Subject: Indian Point 3 Nuclear Power Plant
Docket No. 50-286
Modifications of the Control Room (CR) Ceiling
Eggcrate Ceiling Supports

DESCRIPTION OF MODIFICATION
TO THE CR CEILING EGGCRATE CEILING SUPPORTS

POWER AUTHORITY OF THE STATE OF NEW YORK
INDIAN POINT 3 NUCLEAR POWER PLANT
DOCKET NO. 50-286
April 28, 1983

SKETCH 1

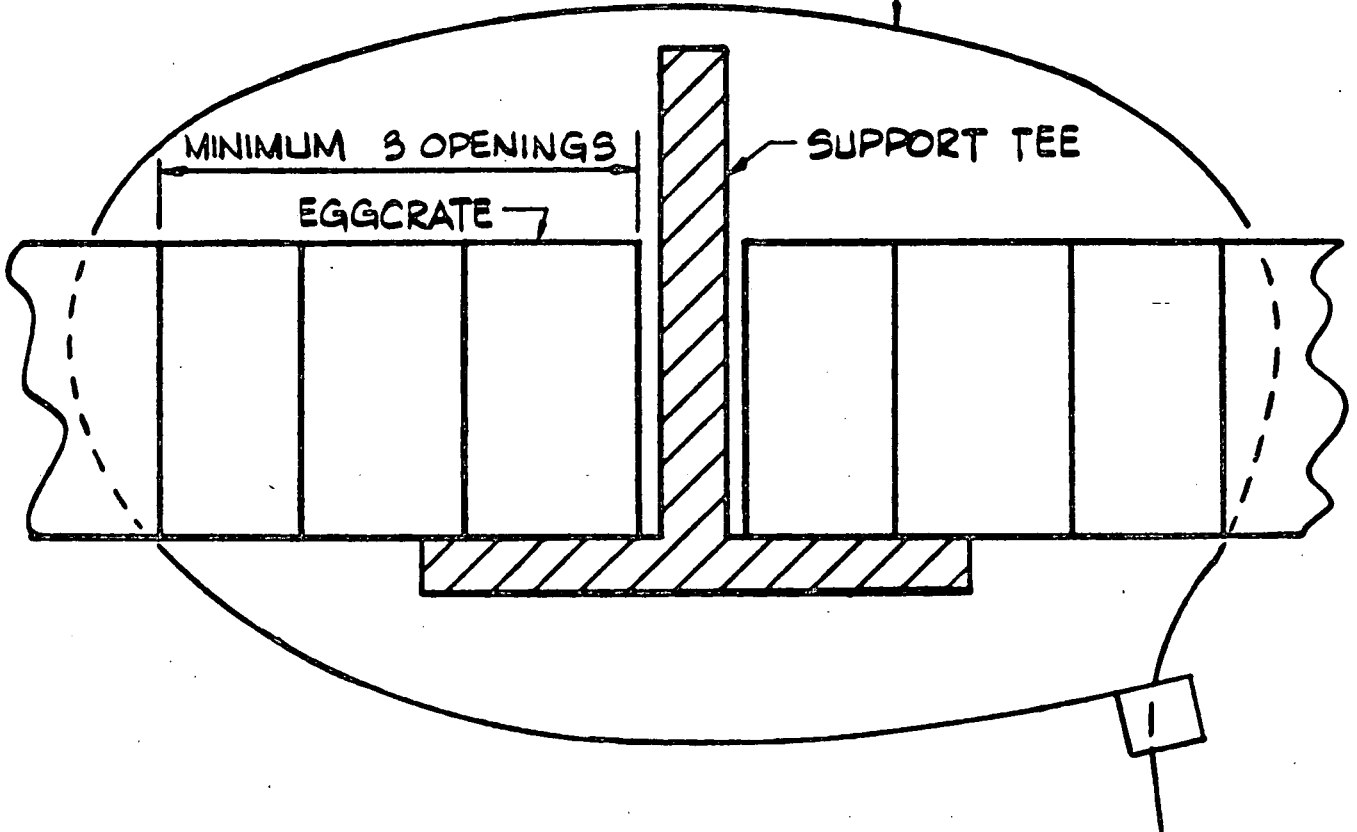
The suggested modification consists of securing the eggcrate ceiling panels to the tee-bar grid by cable ties. This will prevent the panels from falling. The connection of adjacent panels will form a net which is capable of retaining any of the transite panels above from falling onto the control room equipment or operators in the event of a design basis earthquake at the Indian Point Site. In accordance with the Authority's evaluation, the minimum tensile strength of the cable ties required is 50 lbs. (see attached sketch 1).

"PANDUIT CABLE TIE"
MIN. 50LB. TENSILE
STRENGTH
